## NOTICE OF MEETING

The City of Lake Elmo  
Planning Commission will conduct a meeting on  
**Monday, June 23, 2014 at 7:00 p.m.**

PLANNING COMMISSION  
DATE: 6/23/14  
AGENDA ITEM: 4A – PUBLIC HEARING  
CASE # 2014-23

# HUNTERS CROSSING PRELIMINARY PLAT LAKE ELMO, MINNESOTA

PRELIMINARY GRADING AND  
DRAINAGE PLAN

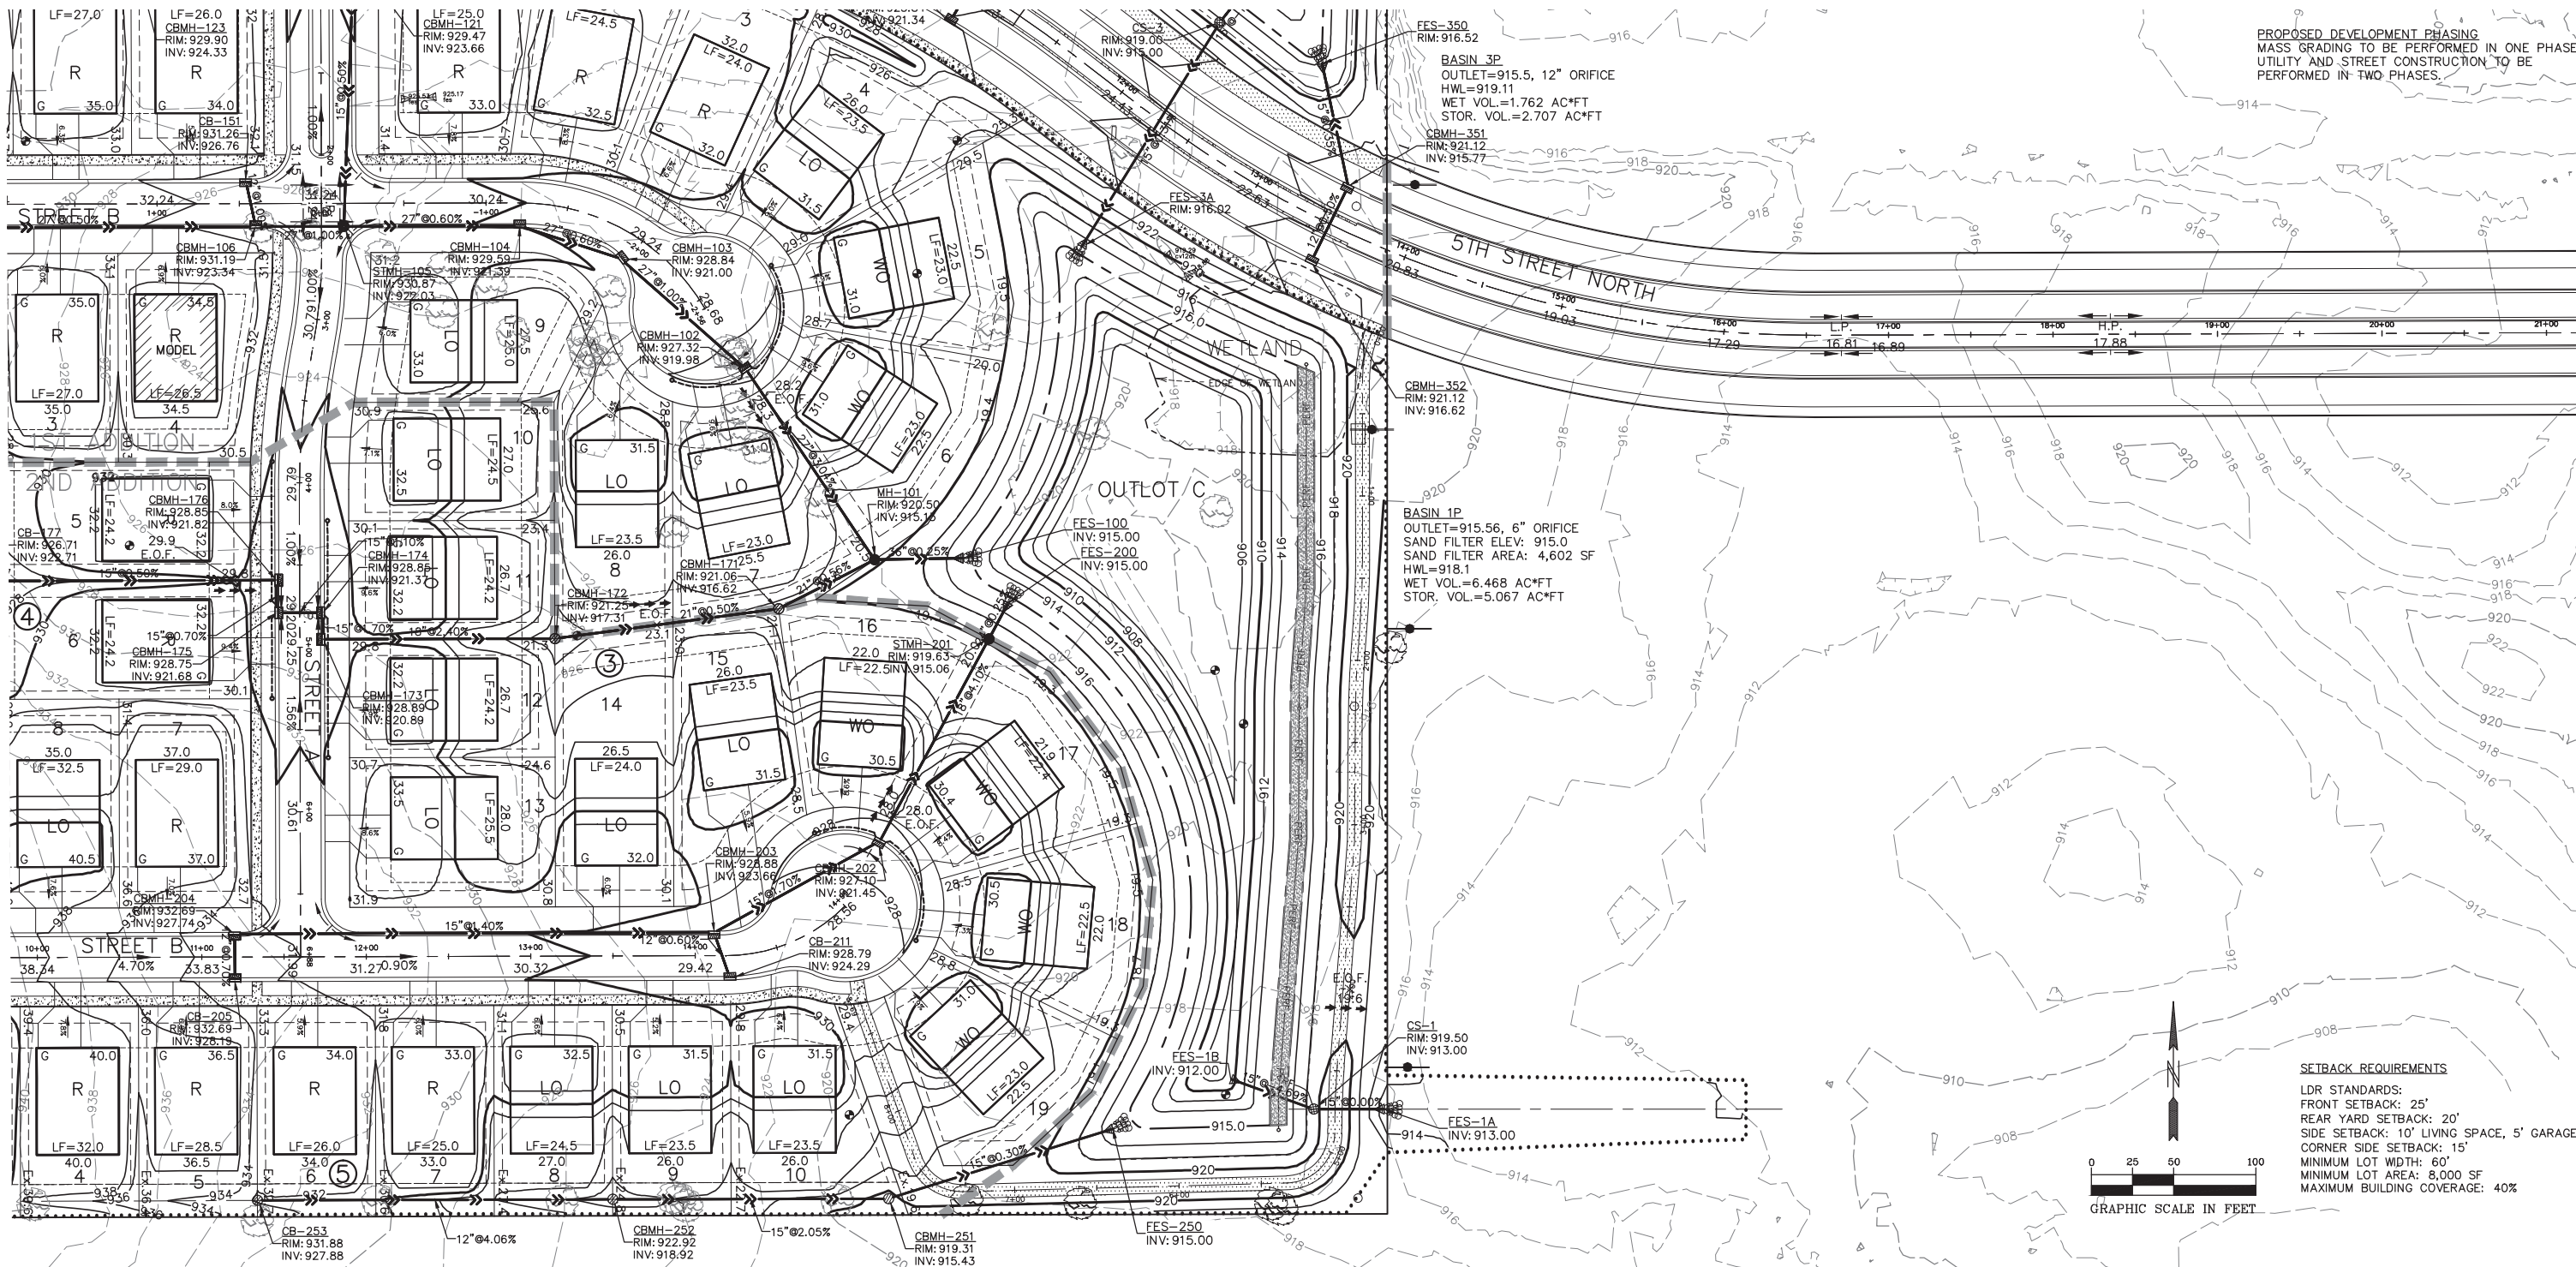
7. Provide overland emergency overflow points for all low points within the Plat. EOFs must be identified with elevation and must be in **BOLD** text.
8. Update the building pad elevations on Sheet 17 to provide the vertical measurement for basement to first floor and from garage floor to first floor.
